<b>CITY OF WESTMINSTER</b>			
<b>PLANNING APPLICATIONS SUB COMMITTEE</b>	<b>Date</b> 12 <sup>th</sup> July 2022	<b>Classification</b> For General Release	
<b>Report of</b> Director of Place Shaping and Town Planning		<b>Ward(s) involved</b> Bryanston And Dorset Square	
<b>Subject of Report</b>	<b>129 - 137 Marylebone Road, London, NW1 5QD</b>		
<b>Proposal</b>	Variation of conditions 1 (approved plans), 14 (Operational management plan for terraces), 28 (plant screen design) and 30 (Mews design details) pursuant to planning permission dated 13 July 2021 (RN. 20/06929/FULL) for Demolition and redevelopment of the mews building, partial demolition of the 1960s building and roof extension, facade alterations to the 1930s building all in connection with continued Class E use, associated cycle parking, landscaping, servicing area, external terraces, rooftop plant enclosure and associated external works. NAMELY external alterations including changes to the rooftop plant enclosure, mansard roof pitches, access to the mews building and other external changes.

<b>Agent</b>	Gerald Eve LLP		
<b>On behalf of</b>	AG Beltane Marylebone B.V.		
<b>Registered Number</b>	21/06044/FULL	<b>Date amende

Substitute Drawing: MH-FPA-XX-DR-A-21000 REV 03

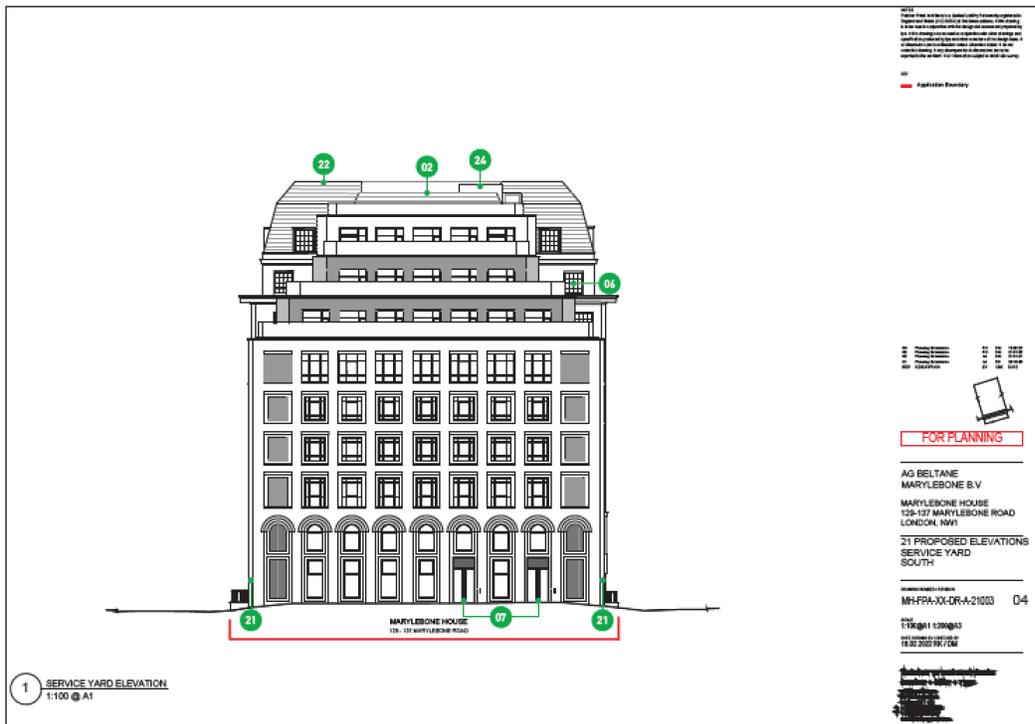
1. New architectural metalwork railings to match existing 1930s Juliette balconies.
2. Slate screen with planting concealing mechanical ventilation ductwork, setback from building profile.

3. Fire exit door fan-light omitted to achieve door height above 2.5m.
4. Rainwater downpipe added to mews building.
5. Window to replace utility garage door - Detail design to be agreed via Condition 30.

11. **Dry riser position indicated following consultation with London Fire Brigade.**
12. Existing lightwell to remain.
13. Natural smoke ventilation breakout panels added to Mews Building front gardens to meet Building Regulations [Fire - Part B].

22. **Mansard pitch design amended to incorporate a shoulder with a change in pitch of 25°.**
23. New open railed lightwell instated.
24. Grey anodised aluminium finish to stair overrun to match roof slate colour.

East Elevation: Knox Street (Proposed)

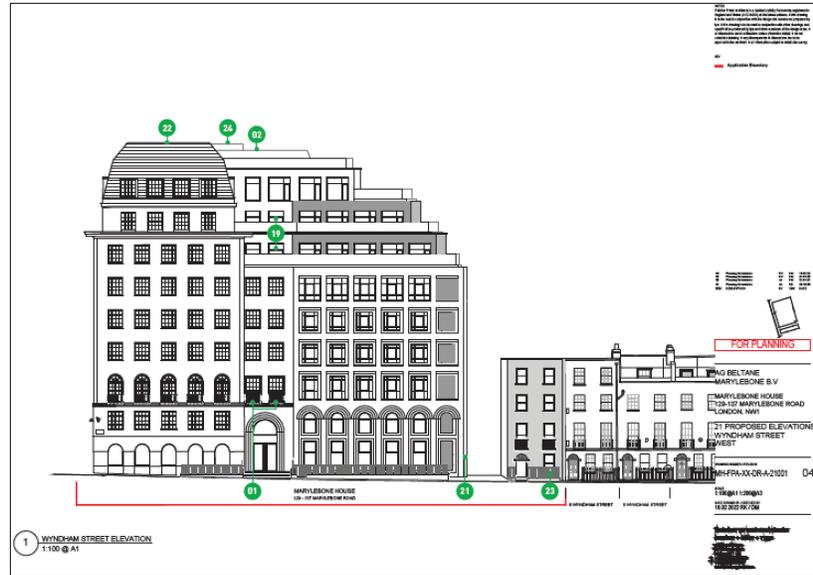
1. New architectural metalwork railings to match existing 1930s Juliette balconies.
2. **Slate screen with planting duct concealing mechanical ventilation ductwork, setback from building profile.**

20. Automatic opening smoke vent to stairwell.
21. **Birdsmouth detail incorporated to facade corners from L06-L05 to alleviate vehicular impact concerns.**

22. **Mansard pitch design amended to incorporate a shoulder with a change in pitch of 25°.**
23. New open railed lightwell instated.
24. **Grey anodised aluminium finish to stair overrun to match roof slate colour.**

Ground Floor Plan (Proposed)

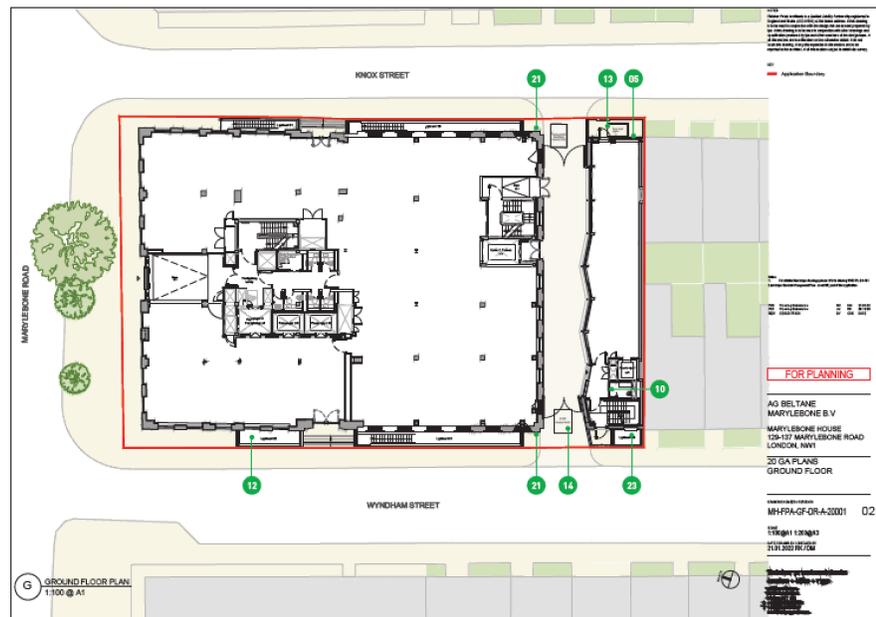
1. New architectural metalwork railings to match existing 1930s Juliette balconies.
2. Slate screen with planting concealing mechanical ventilation ductwork, setback from building profile.

3. Fire exit door fan-light omitted to achieve door height above 2.5m.
4. Rainwater downpipe added to mews building.
5. Window to replace utility garage door - Detail design to be agreed via Condition 30.

11. Dry riser position indicated following consultation with London Fire Brigade.
12. Existing lightwell to remain.
13. Natural smoke ventilation breakout panels added to Mews Building front gardens to meet Building Regulations (Fire - Part B).

## Lower Ground Floor Plan (Proposed)

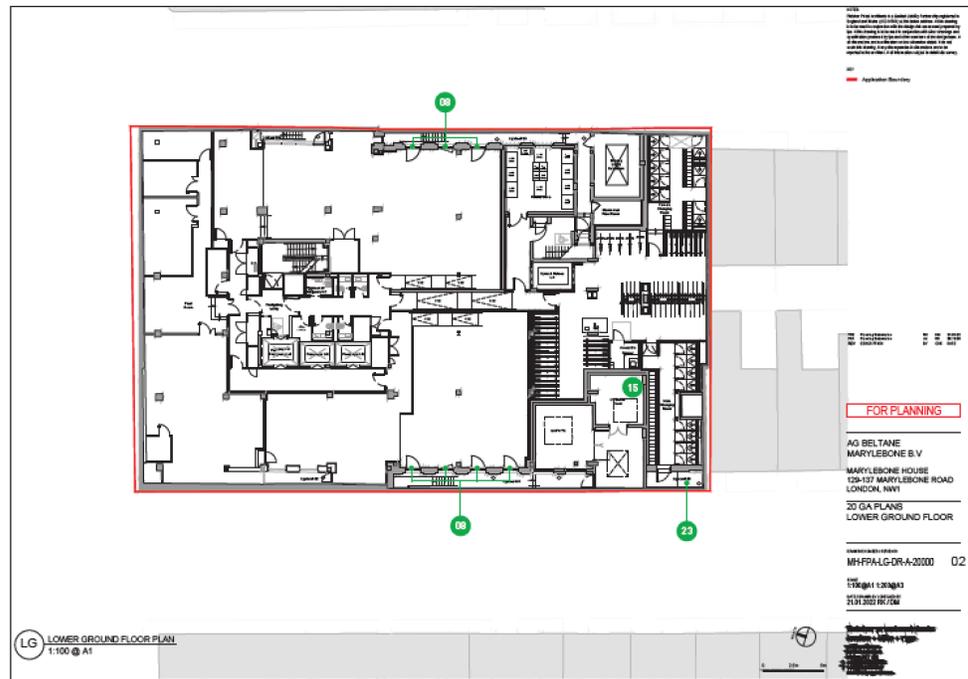
14. Existing and new transformer access hatches to UKPN substation indicated.
15. **UKPN Substation detail design incorporated. Lower ground floor general arrangement amended to maintain cycle, shower and locker provisions.**

22. Mansard pitch design amended to incorporate a shoulder with a change in pitch of 25°.
23. **New open railed lightwell instated.**
24. Grey anodised aluminium finish to stair overrun to match roof slate colour.

## Ninth Floor Plan (Proposed)

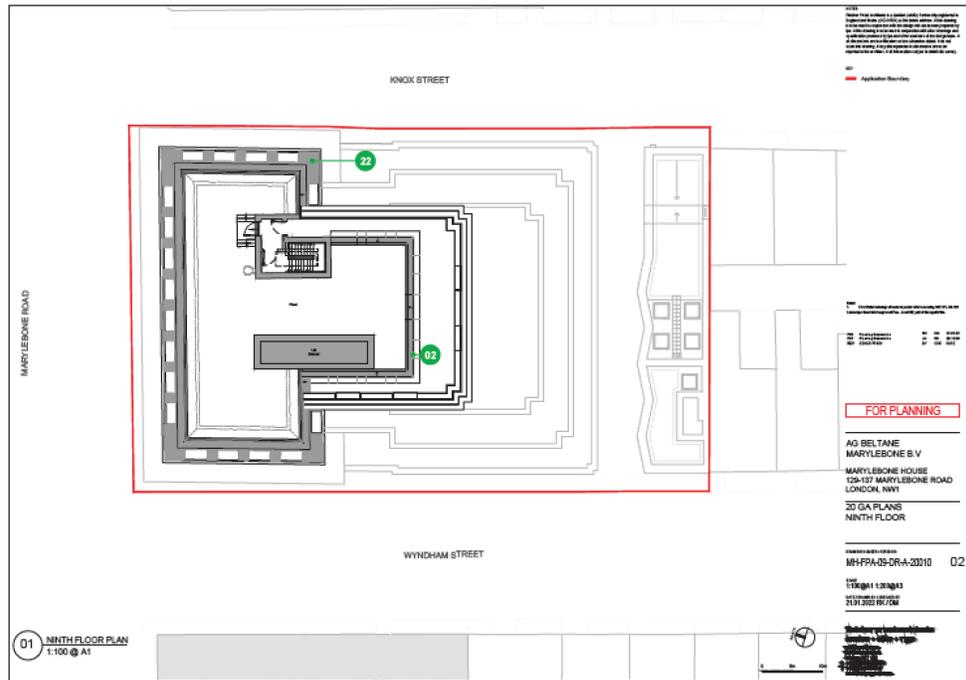
1. New architectural metalwork railings to match existing 1930s Juliette balconies.
2. **Slate screen with planting concealing mechanical ventilation ductwork, setback from building profile.**

20. **Mansard pitch design amended to incorporate a shoulder with a change in pitch of 25°.**
21. New open railed lightwell instated.
22. Grey anodised aluminium finish to stair overrun to match roof of slate colour.
